Memorandum

Subject : Timber Harvesting Plan 1-88-041 MEN.
Ray Gulch, Navarro River, Mendocino County.

THP 1-88-041 MEN

MAP TO ACCOMPANY
 TIMBER HARVESTING PLAN
 Pardini - East Barton Gulch - Louisiana Pacific All roads are seasonal.

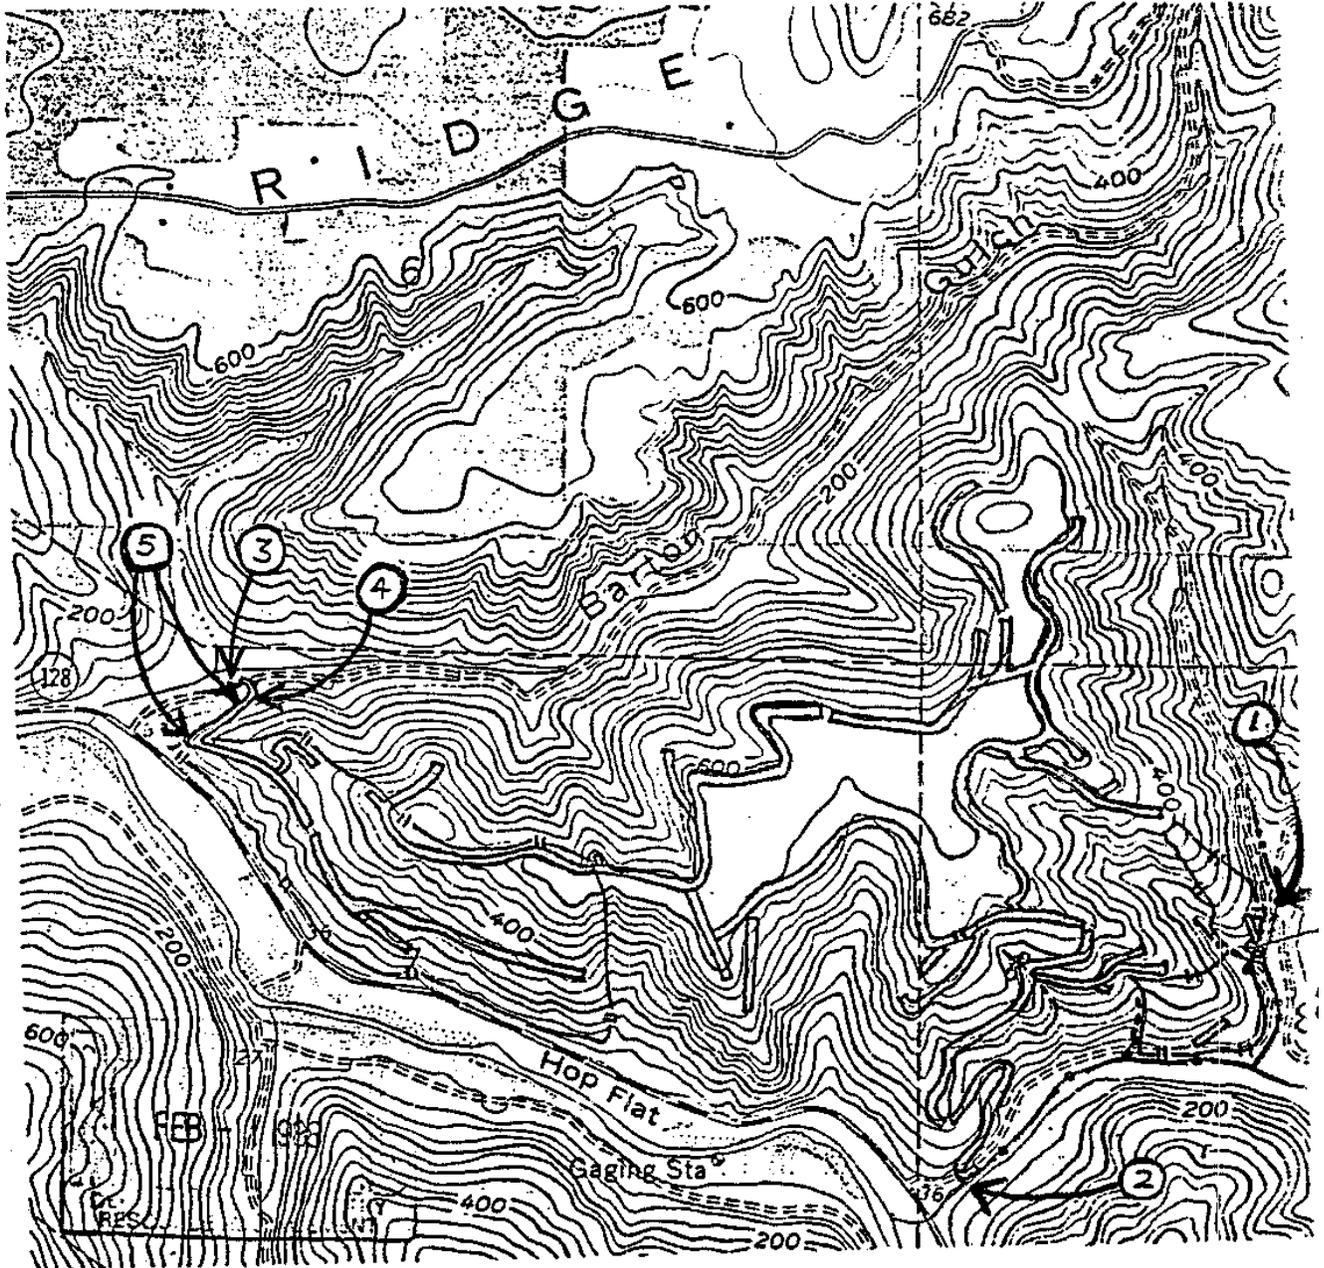
1. The Class I watercourse extends at least to the edge of the plan area at Area 1. Jim Purcell indicated he had seen a fish at the road crossing in the past. The pond extends south of Area 1 along the east edge of the plan area.

3. At Area 3, the proposed road is within the 50 foot WLPZ of a flowing channel of Barton Gulch. The proposed road is at the elevation of the flood plain for a distance of approximately 150 feet. This section of road will require special attention if use of a new road within the WLPZ will result in equal protection for the watercourse. We were unable to agree upon the best reasonable method needed to protect this area. Department of Fish and Game's concerns include: 1) The RPF did not recognize it was within the WLPZ; 2) A new road will be constructed upslope of this area; 3) The new road is on steep slopes with a steep road gradient between Areas 4 and 5.

The old roadbed within the WLPZ at Area 3 is intact and does not show evidence of gullyng or surface erosion. Concern is based on use of the road that will disturb the area resulting in erodible soil entering the stream. Elsewhere when roads are constructed in such areas the road is not stable unless special care is used. Fine material can be; "pumped" up through heavy rock in such areas when heavy loads are hauled across them. Water and mud can collect on the road in areas where it will be discharged to the watercourse during use or storm runoff.

4. Q. Evaluate Ray Gulch and the pond for fish.
 - A. Evaluated. No fish were seen, however, Jim Purcell indicated he had seen fish upstream to Area I. The RPF has agreed to extend the Class I . watercourse to Area 1.
5. Q. Evaluate new road construction. Are any stability problems expected?
 - A. Evaluated. In addition to other stability problems, some problems are anticipated at Area 3 unless special precautions are utilized. The roadbed at Area 3 is on grade at the edge of the flood plain. Flowing water in a channel within the f lood plain is within 50 feet of the proposed roadbed. The area of concern is approximately 150 feet long at the edge of the flood plain. See Recommendation Number 2.

1. Extend the Class I watercourse to Area 1.
2. At Area 3 stabilize the 150 foot section of the proposed WLPZ road at least equal to stability obtained by using fabric with at least one foot of rock on top.
